DRAWN	S. GOSS	DATE	02JUL14	44425 PECAN COURT, SUITE 151 CALIFORNIA, MARYLAND 20619, USA PH: (410) 326-1590 FAX: (410) 326-1199
CHECKED	R. LAWRIE	DATE	08JUL14	
ENG APPR.	R. KEOWN	DATE	12AUG14	
COMMENTS:				
SEAKEEPER 35 / 30HD GYRO CABLE BLOCK DIAGRAM				
SIZE	DWG NO.		REV	
C	90288		4	
SCALE	N/A	WEIGHT	N/A	SHEET 1 OF 1

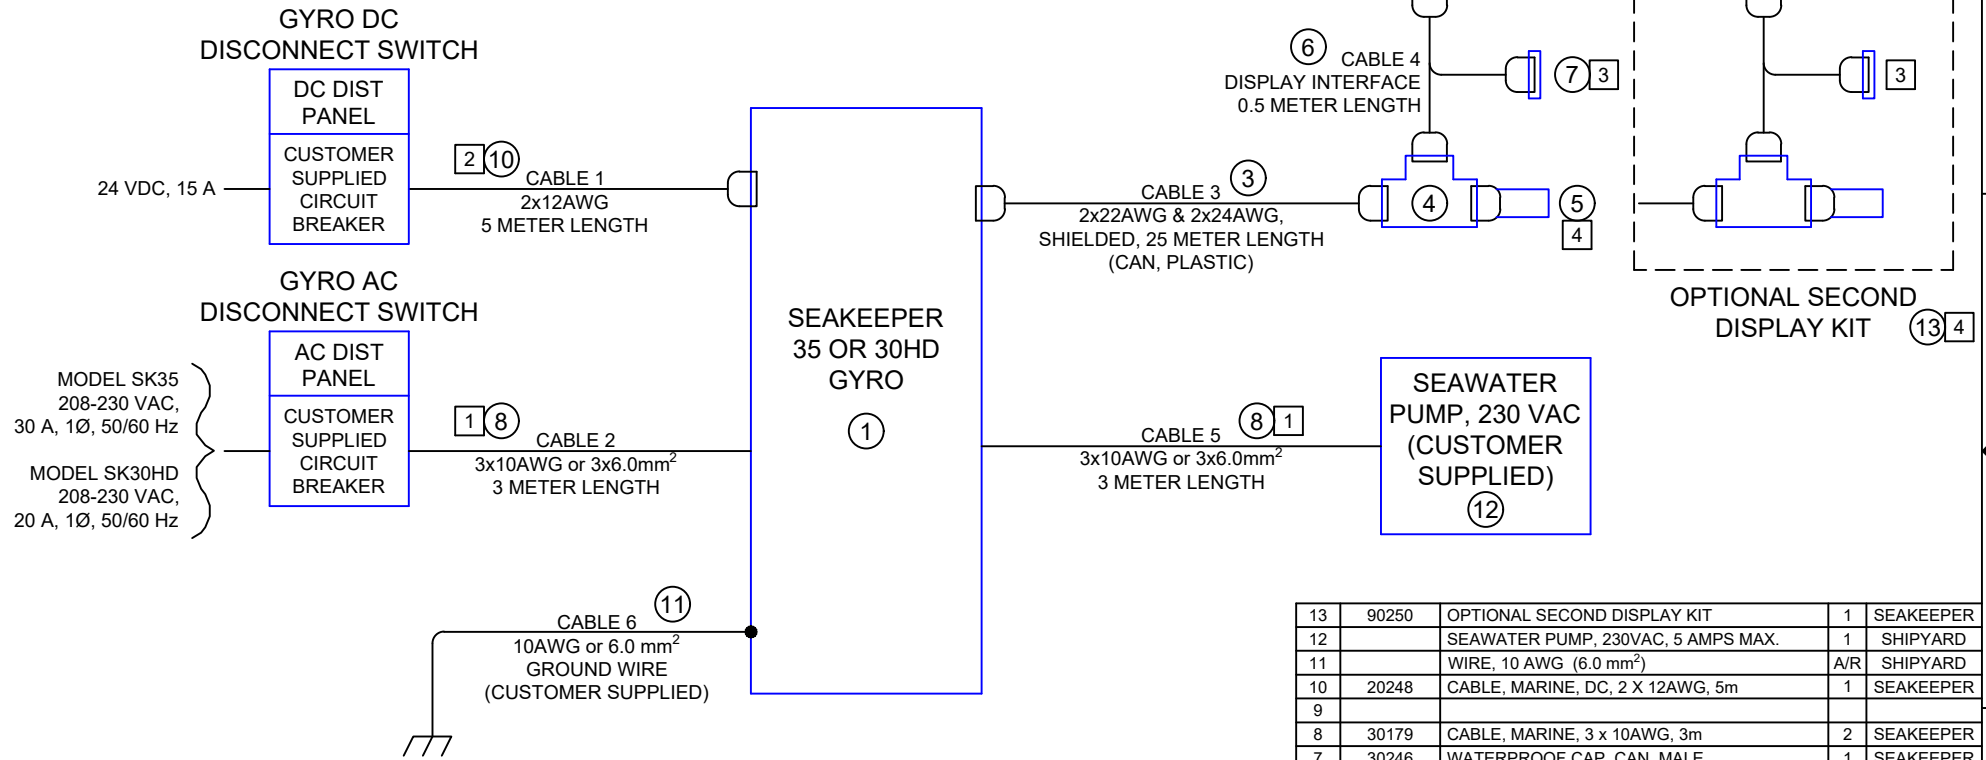
REVISIONS					
REV	ECN NO.	ZONE	DESCRIPTION	DATE	APPROVED
2	287	3-F	1. CHANGED DISPLAY AND REMOVED CONN & SEAL.	25FEB15	T. VAN WERT
3	341	4-C P/L	1. CHANGED CABLE 5 MAT'L. WAS 3x10AWG. 2. ADDED CUSTOMER SUPPLIED FUSES ON CBL 5.	10JUL15	T. VAN WERT
4	469	2-A 4-C P/L P/L	1. ADDED MODEL 30HD & REVERTED CBL 5 MAT'L. 2. REMOVED ITEM 14, CUSTOMER SUPPLIED FUSES. 3. CHANGED ITEM 11, WAS 4 AWG.	07DEC16	B.DOUTRICH
